SERVICE BULLETIN

Ref: SRV - 011-006

Product: All Ull reels sold on Honey Bee product.

Re: Cam roller and timing adjustments on Ull reels.

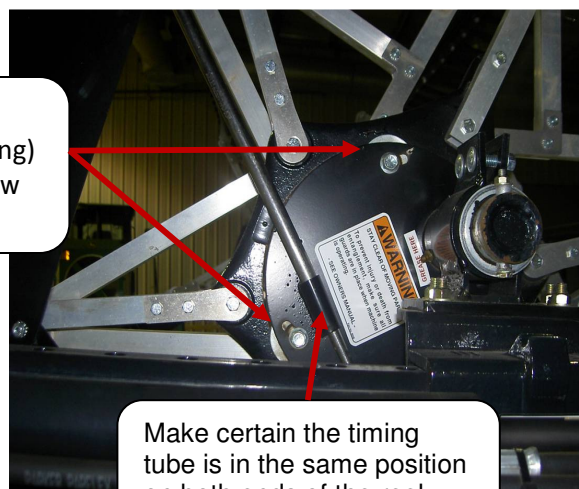
Problem: Improper settings on Ull reel cam or reel timing will cause premature wear on cam ring and or reel.

All three rollers must be lightly touching (or very close to touching) the cast control ring, this will allow a smooth rotation of the reel.

Make certain the timing tube is in the same position on both ends of the reel.

Solution: Adjust cam rollers or reel timing as required.
